**Subject:** DRAFT Response to U.S. EPR Design Certification Application RAI No. 354,  
FSAR Ch. 3, Questions 3.8.2.11-15  
**Sent Date:** 7/30/2010 4:36:08 PM  
**Received Date:** 7/30/2010 4:38:06 PM  
**From:** BRYAN Martin (EXTERNAL AREVA)

**Request for Additional Information No. 354,  
Question 03.08.02-11, Question 03.08.02-12, Question 03.08.02-13,  
Question 03.08.02-14, and Question 03.08.02-15**

**U. S. EPR Standard Design Certification**

**SRP Section: 03.08.02 - Steel Containment**

**Figure 03.08.02-11-1—ANSYS Model (Personnel and Emergency Airlocks)**

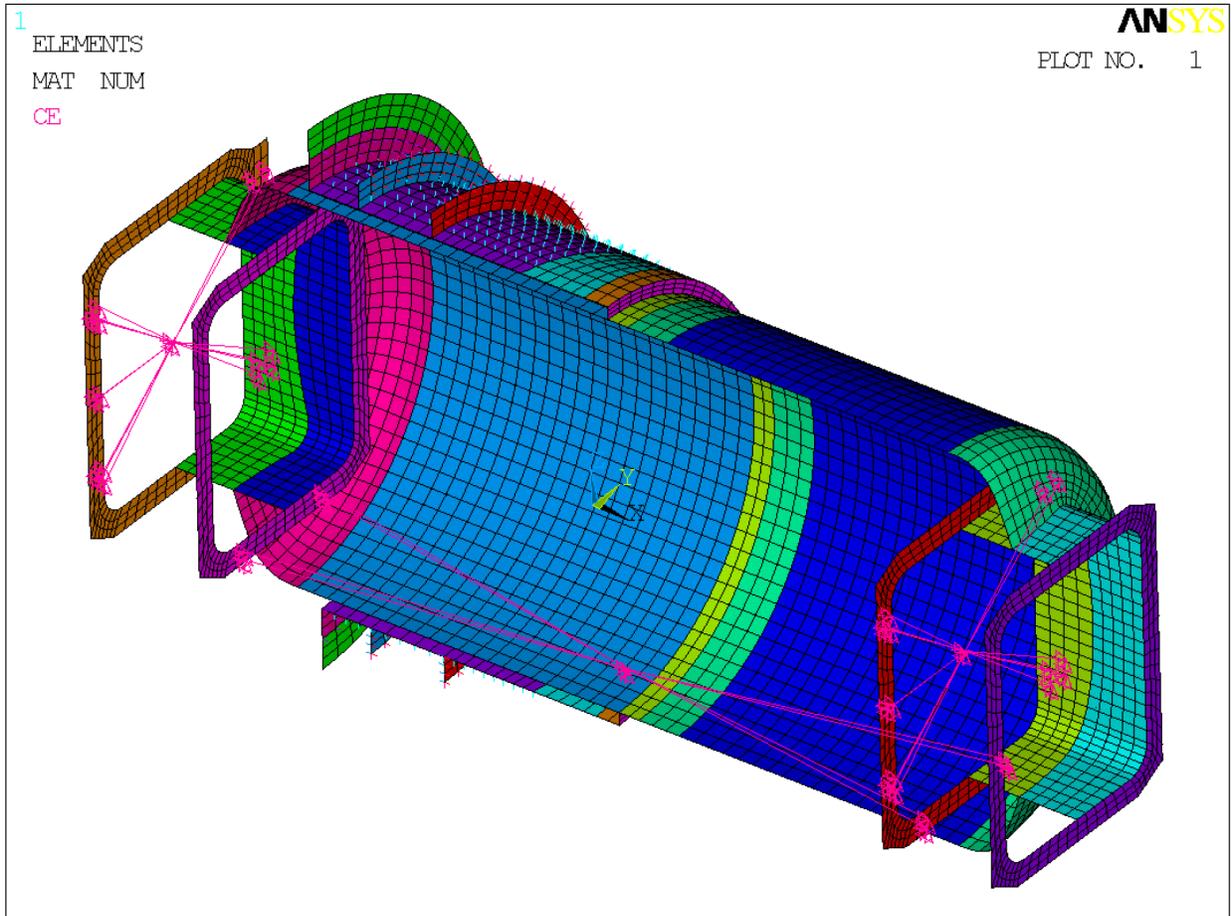
Since the responses to RAIs 03.08.02-1, -2, and -5 did not provide a sufficient description summarizing the design of penetrations, the staff requests that the applicant submit the following information for the equipment hatch, the air locks, the closure for the construction opening, and the high energy piping penetrations that fall within the jurisdictional boundary of ASME Section III, Subsection NE:

- (1) material(s) of construction and detailed geometry;
- (2) description of the design-basis analyses conducted;
- (3) summary of the analysis results; and
- (4) comparison of results to ASME Section III, Subsection NE acceptance criteria.

Analysis methods use finite element modeling techniques to represent the penetration assemblies and interfaces at the containment boundary. Figure 03.08.02-11-1 is used to evaluate the personnel and emergency airlocks. Loads and load combinations for design, testing, and Service Levels A, B, C, and D are evaluated. Load cases consider conditions of operations, e.g., inner hatch closed or open, loadings associated with ancillary equipment of the penetration such as hatch doors, and built-up floors.

The stresses resulting from the evaluations are tabulated and compared to the stress limits determined in accordance with ASME Boiler and Pressure Vessel Code 2004, Section III, Division 1, Subsection NE (Class MC Components) for each loading condition and verified for compliance.

Figure 3.8-25—Equipment Hatch General Assembly

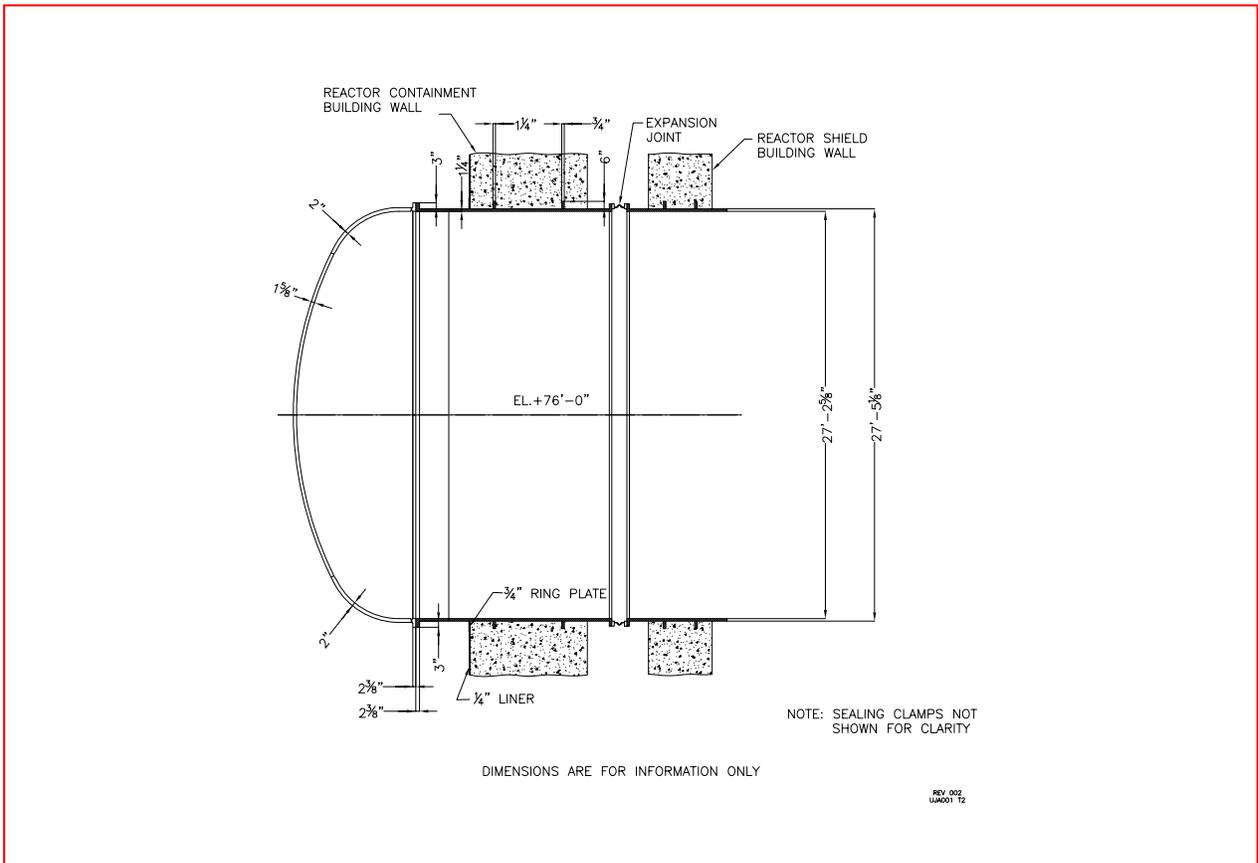
While the information provided in the initial RAI response is helpful to understand how AREVA plans to accommodate differential movement between the RCB and the RSB, the staff needs additional description and detail before it can complete its review of this design aspect. The staff's primary concern is the integrity of the containment pressure boundary. Therefore, the staff requests that AREVA describe the loads that are imposed on the containment penetrations due to differential movement between the RCB and the RSB, and also describe how these loads are considered in the design of the containment penetrations.

The personnel airlock, emergency airlock, and equipment hatch contain flexible expansion joints which connect the RCB penetration sleeves to the RSB penetration sleeve to allow differential movement and minimize load transfer between the RCB and RSB. U.S. EPR FSAR Tier 2, Sections 3.8.2.1.1 and 3.8.2.4.1 will be updated to describe the expansion joints. The bellows provide a boundary for annulus ventilation. The stiffness is expected to have no effect on the qualification of the penetration sleeves. The equipment hatch is shown in U.S. EPR FSAR Tier 2, Figure 3.8-25, and the personnel airlock and emergency airlock are shown in U.S. EPR FSAR Tier 2, Figure 3.8-26.

The equipment hatch, illustrated in Figure 3.8-25 is a welded steel assembly with a double-~~gasketed~~sealed, flanged, and bolted cover. ~~Provision is made for leak testing of the flange gaskets by pressurizing the annular space between the gaskets.~~ The cover for the equipment hatch attaches to the hatch ~~barrel~~sleeve from inside of the RCB. The cover seats against the sealing surface of the ~~barrel~~penetration sleeve mating flange when subjected to internal pressure inside the RCB. The RCB penetration sleeve and the RSB penetration sleeve are connected by an expansion joint to allow for differential movement between the two walls, as shown in Figure 3.8-25. The

Figure 3.8-31—Fuel Transfer Tube Penetration (Conceptual View)

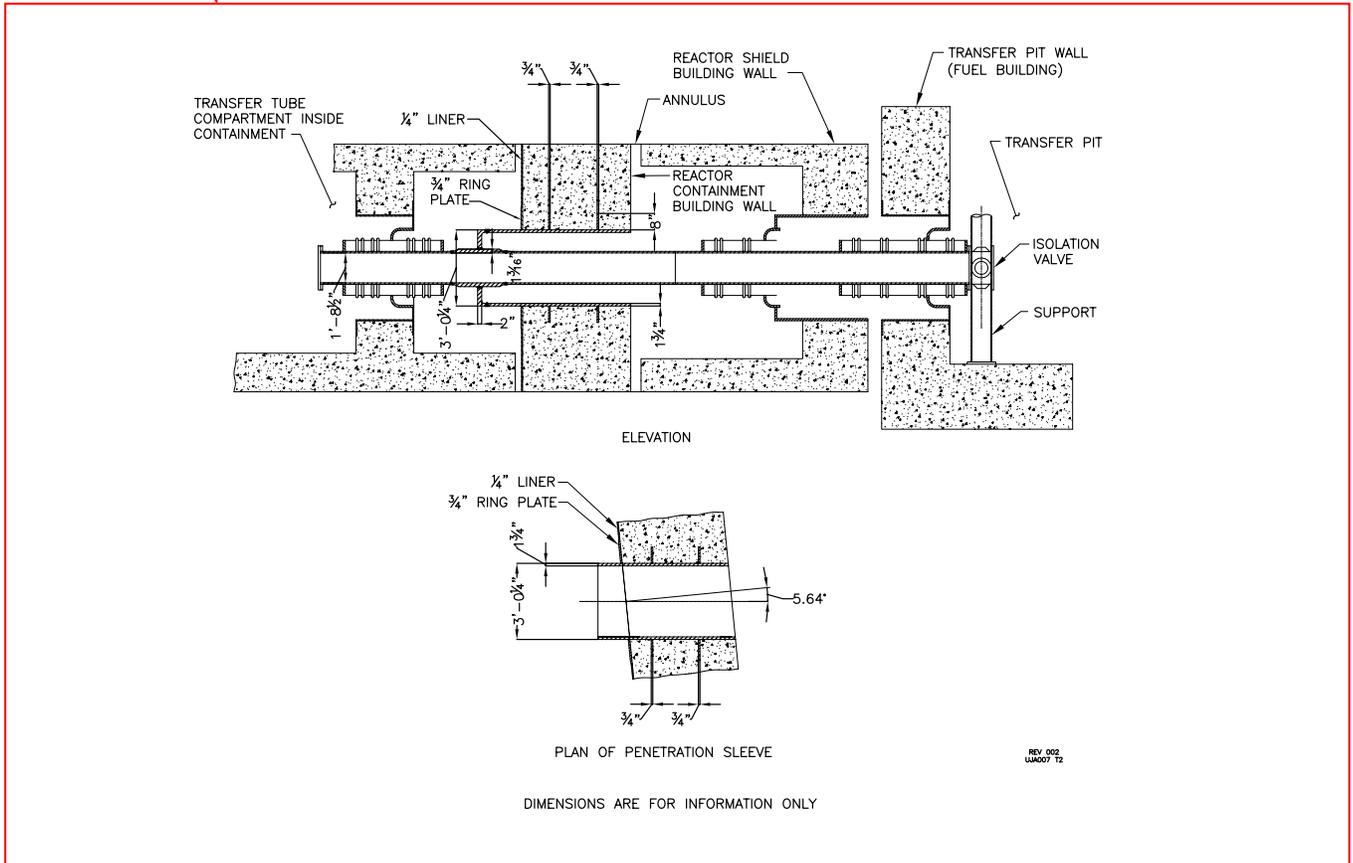
1. Provide sufficient details for all components of the penetration closure within the jurisdictional boundary of the RCB. These details should include sufficient information to determine adequacy of the load path (e.g. key structural members in the load path, anchorage of key components to RCB, etc.).

2. FSAR Tier 2, Section 9.1.4.2.2 states: "The fuel transfer tube is provided with expansion joints on the RB and FB side to accommodate the differential movement and provide leak tight sealing." The staff cannot assess the adequacy of the design based on this statement alone. Provide sufficient description and details of the expansion joints to facilitate the staff's review of the design adequacy to accomplish the intended functions which were stated to be differential movement and leak-tightness. At a minimum, this should include material, geometry, and a summary of analyses performed, analysis results, and comparison to acceptance criteria.

1. The Reactor Containment Building (RCB) is a concrete containment structure with a metallic liner and is designed to the requirements of ASME Code, Section III, Division 2. Where the fuel transfer tube penetration sleeve is backed by concrete, the penetration is designed to ASME Code, Section III, Division 2. The jurisdictional boundary changes where the penetration sleeve is not backed by concrete. The portion of the sleeve not backed by concrete and appurtenances attached to the sleeve are designed to the requirements of ASME Boiler and Pressure Vessel Code 2004, Section III, Division 1, Subsection NE (Class MC Components). The containment boundary consists of the penetration sleeve, liner plate, ring plate, bride, fuel transfer tube, and blind flange.

The fuel transfer tube penetration sleeve is nominally 3/4 inch thick, 36 inches in diameter, and embedded in the RCB wall. Penetration sleeve anchors verify distribution of applied forces and moments between the concrete and the sleeve. The two sleeve anchors are nominally 3/4 inch thick plate, eight inches in height, and continuously welded around the circumference of the sleeve. The portion of the penetration sleeve backed by concrete and the embedded anchors are designed to ASME Code, Section III, Division 2, Section CC-3740.

The fuel transfer tube penetration sleeve is welded to the containment liner plate by means of a transitional ring plate continuously welded around the circumference of the sleeve. The ring plate is nominally 12 inches in height, 7/8 inch thick tapering to 1/4 inch at the liner plate connection, which is a complete penetration weld. The penetration sleeve is connected to the stainless steel fuel transfer tube through a fabricated "bride" fitting. The bride fitting is welded to fuel transfer tube.

U.S. EPR FSAR Tier 2, Figure 3.8-31 will be revised to depict the location of the penetration sleeve anchors and blind flange. U.S. EPR FSAR Tier 2, Section 3.8.2.1.4 will be revised to include the diameter of the fuel transfer tube penetration sleeve.

The fuel transfer tube expansion bellows shown in U.S. EPR FSAR Tier 2, Figure 3.8-31 allow for differential movement, but are not part of the containment pressure boundary. The stiffness of the expansion bellows for the fuel transfer tube is modeled in a sub-model as springs connected to fixed nodes.

Figure 3.8-122—Medium Voltage Electrical Penetration Sleeve

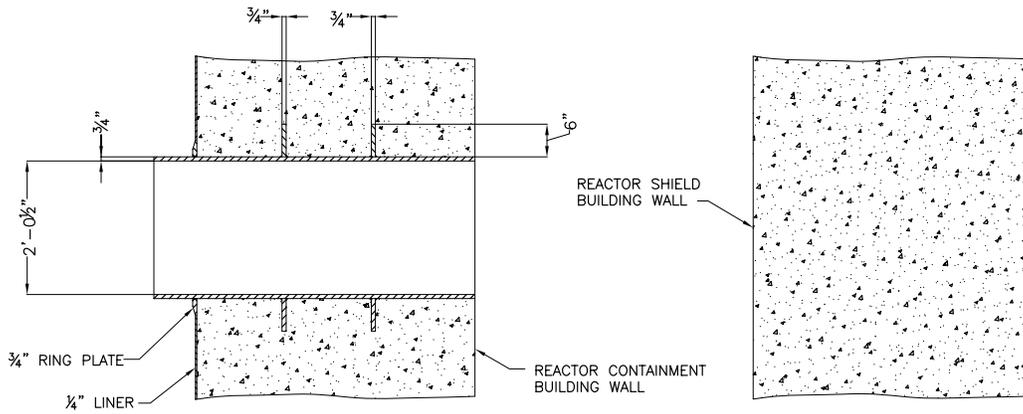
The staff reviewed the electrical penetration figures provided with the initial RAI response. They are acceptable to describe typical electrical penetrations. However, there is no information on the design of the sleeves that support the electrical penetrations. The staff requests that the applicant provide the following additional information:

1. range of penetration diameters,
2. sleeve material and thickness, and
3. method of analysis used to demonstrate adequacy of the sleeve and its anchorage into concrete.

1. Electrical penetration sleeve diameters range from 18 to 24 inches (nominally).
2. The Reactor Containment Building (RCB) is a concrete containment structure with a metallic liner and is designed to the requirements of ASME Code, Section III, Division 2. Where the electrical penetration sleeve is backed by concrete, the penetration is designed to ASME Code, Section III, Division 2 standards. The jurisdictional boundary changes where the penetration sleeve is not backed by concrete. The sleeve and appurtenances not backed by concrete are designed to the requirements of ASME Boiler and Pressure Vessel Code 2004, Section III, Division 1, Subsection NE (Class MC Components). Penetration sleeve materials are per ASME Code, Section III, Division 2, and as summarized in U.S. EPR FSAR Tier 2, Table 6.1-1.

The electrical penetration sleeves are nominally 5/8 inch to 3/4 inch thick and embedded in the RCB wall. Penetration sleeve anchors are included to verify distribution of applied forces and moments between the concrete and the sleeve. The two sleeve anchors are nominally 3/4 inch thick, six inches in height, and continuously welded around the circumference of the sleeve. The penetration sleeve and anchors are designed to ASME Code, Section III, Division 2, Section CC-3740 standards. The electrical penetration sleeves are welded to the containment liner plate by means of a transitional ring plate continuously welded around the circumference of the sleeve. The ring plate is nominally 3/4 inch thick tapering to 1/4 inch at the liner plate connection, which is a complete penetration weld. U.S. EPR FSAR Tier 2, Section 3.8.2.1.3 will be updated and Figures 3.8-121 and 3.8-122 will be added to depict the location of the penetration sleeve anchors.

Typical details of electric penetrations are illustrated in Figure 3.8-121—Low Voltage Penetration Sleeve and in Figure 3.8-122—Medium Voltage Penetration Sleeve.
